# DOWNSTREAM AQUATIC HABITAT STUDY REPORT

R.L. HARRIS HYDROELECTRIC PROJECT

FERC No. 2628

Revised November 2021

**FIGURE 3-2 MESOHABITAT CLASSIFICATIONS – HARRIS DAM TO MALONE**

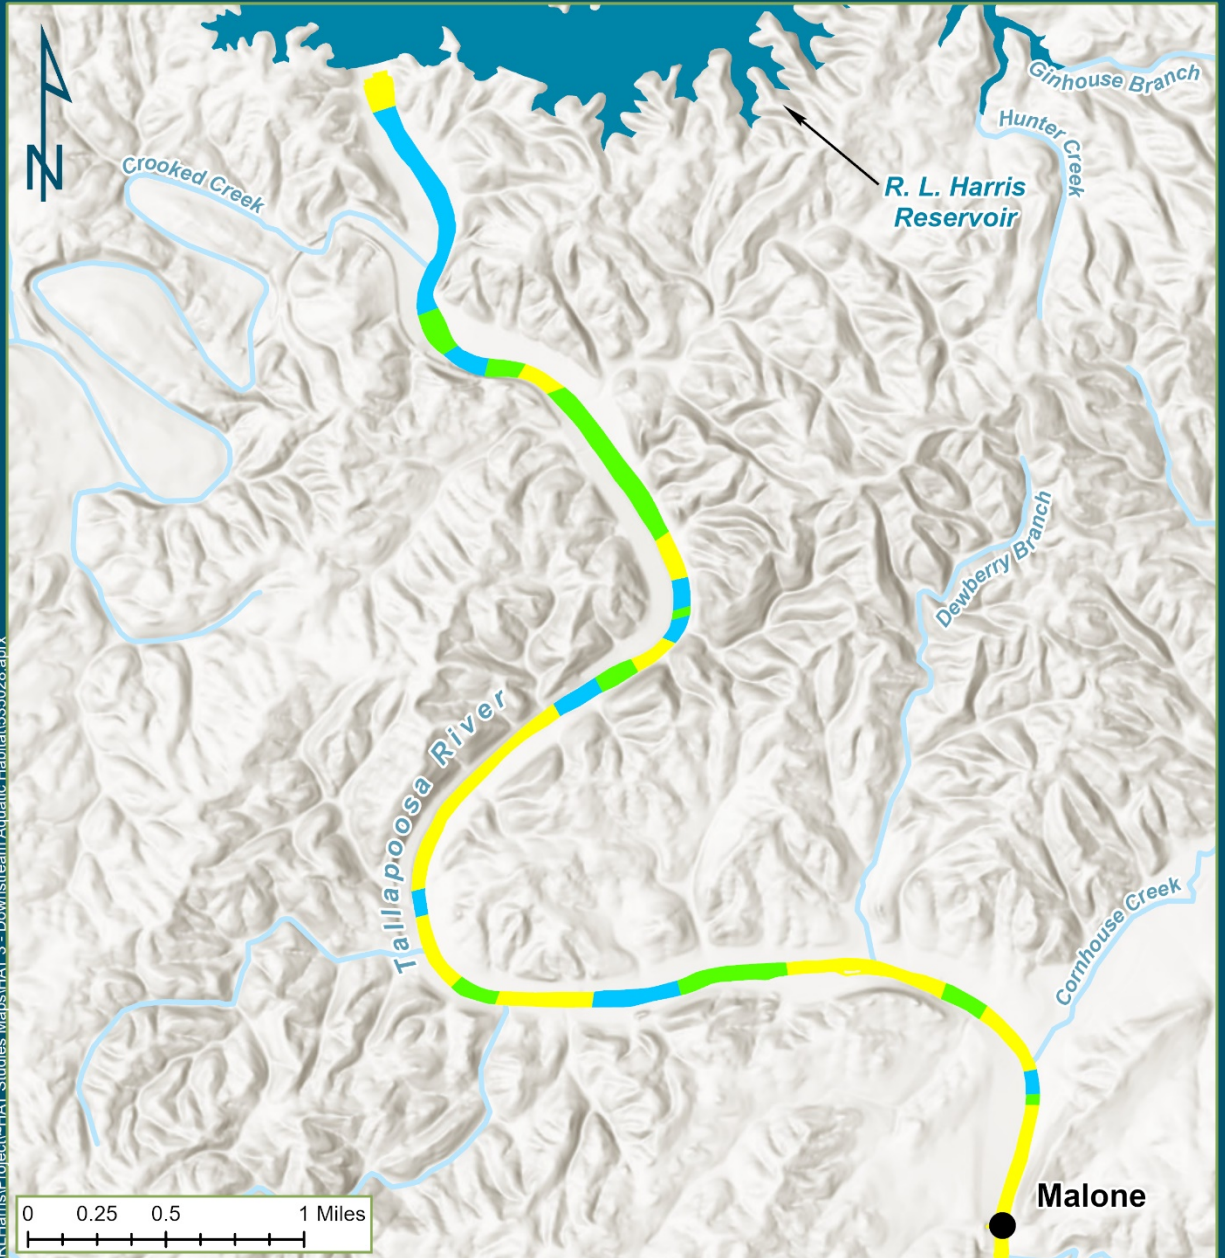
<b>ADCNR</b>		On page 9, Figure 3-2 of Draft Downstream Aquatic Habitat Report, the image resolution is poor. If available provide higher resolution images for this data.	This was corrected in the Final Report.
<b>ADCNR</b>		On page 10, section 3.2.1 Study Period Hydrology and Climate, of Draft Downstream Aquatic Habitat Report, provide statistical analysis information documenting that significant differences occurred between the river flows in August/September 2019 and January/March 2020 compared to long-term averages.	The word “ <i>significantly</i> ” was removed in the Final Report.
<b>ADCNR</b>		On page 14, Figure 3-6, of Draft Downstream Aquatic Habitat Report, provide standard deviation bars for the average daily water level.	Standard deviation was added to the tabular summary.
<b>ADCNR</b>		On page 14, of Draft Downstream Aquatic Habitat Report, provide an additional graph similar to Figure 3-6 that depicts the maximum daily water level fluctuation (Delta T) from May 2019 to April 2020. This graphic will better represent the unnatural, harsh conditions subjected to aquatic fauna daily below Harris Dam.	Maximum daily water level fluctuation is provided in the tabular summaries in Tables 3-3 and 3-4.
